JJMA DWG NO. 2718M-SI-1-3

MARINE DESIGN DIVISION		U. S. ARMY ENGINEER DISTRICT, PHILADELPHIA CORPS OF ENGINEERS OFFICE OF THE DISTRICT ENGINEER	
DESIGNED BY <i>J.J.M.</i>	CHECKED BY <i>J.N.</i>	HULL NO. 354 MEDIUM CLASS DREDGE	
SUBMITTED BY <i>Scott Bullman</i>		GENERAL ARRANGEMENT	
APPROVED BY <i>Scott Bullman</i>		HOLD & MAIN DECK	
DATE NOV 1978		NO. 354-H140-0005	REV. NO. A
SCALE 1/8" = 1'-0"		SHEET 5 OF 5

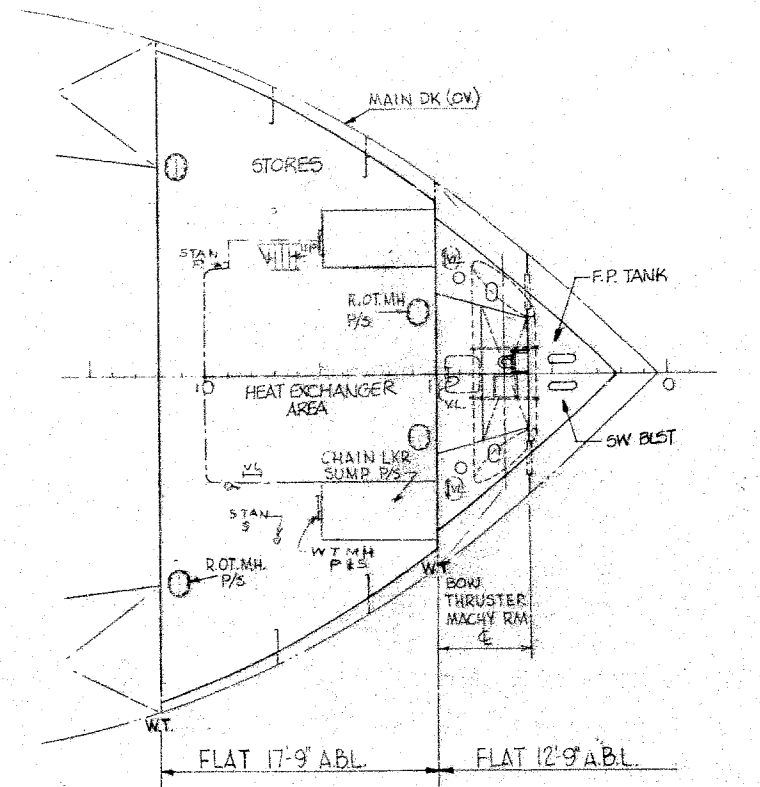
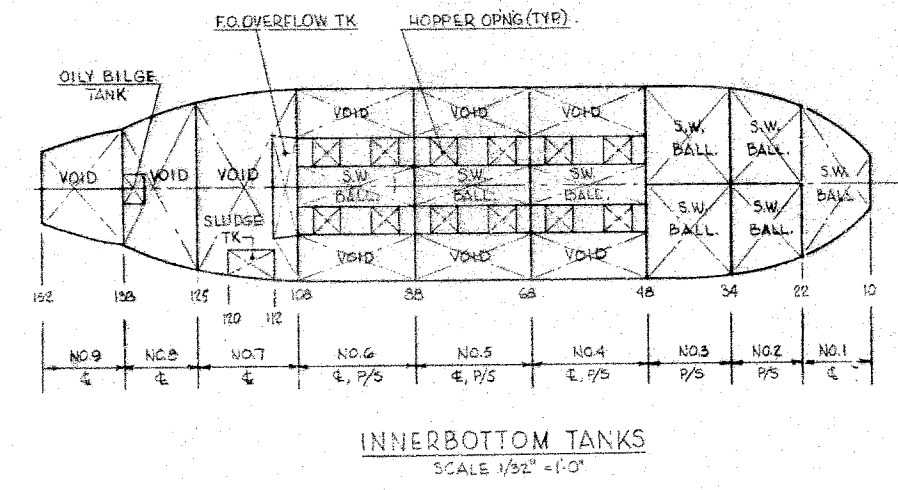
NO.	DESCRIPTION	DATE	APP'D.
4F	1. MAIN DECK - ADDED 4'-0" x 4'-0" (DK OPNG (OVER) STAIN FR 204 FR 24, P/S - DELETED W/TATT CRG STAIN FR 274 FR 20, P/S.		
4F	2. MAIN DECK - REVISED INCLINE LADDER IN MOTOR ROOM.		
4C	3. HOLD - REVISED INCLINE LADDER IN MOTOR ROOM - ADDED SL W/TATT CRAT BHD 34.		
9F	4. MAIN DECK - HOLD - ENLARGED DECK STAIN IN ENGINE ROOM.		
9B	5. HOLD - REVISED INCLINE LADDER IN AUX MCHRY RM.	1-24-79	D.M.
